DISHDRAWER

DW025

June 2001

KICK STRIP DEFECT PHASE 3 DISHDRAWER (NZ, AUS, USA, UK)

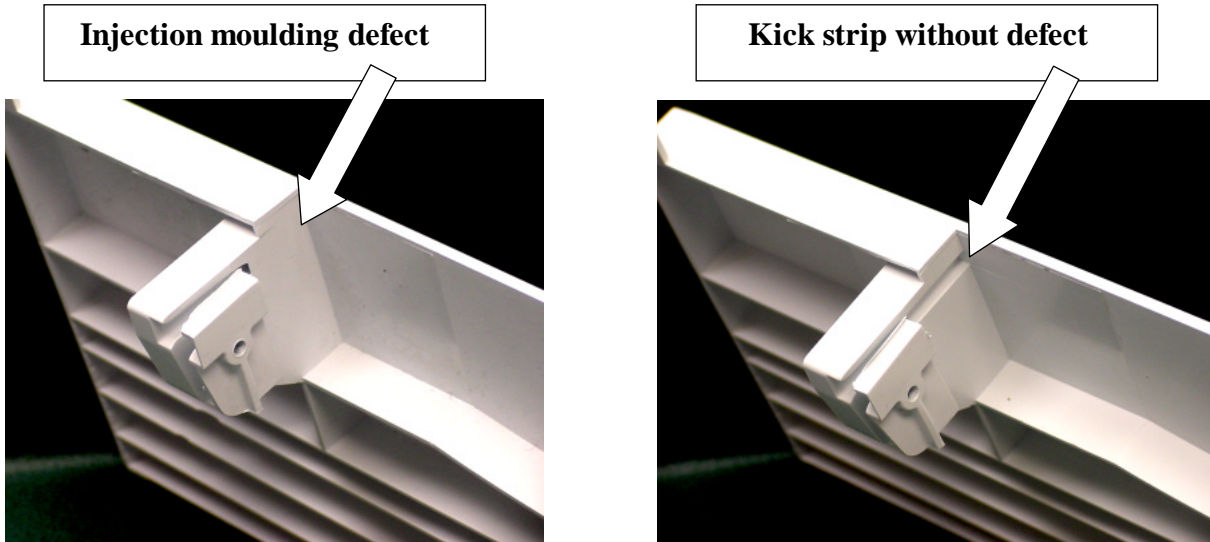
We have found a batch of phase 3 kick strips with an injection-moulding defect around the mounting detail. The implications are that if a kitchen toe kick is any deeper than 50mm it may not be possible to slide the kick strip far enough back on the tub to line up with the adjacent joinery. If this problem is encountered, simply cut away the thin piece of plastic that is interfering. Refer pictures below.
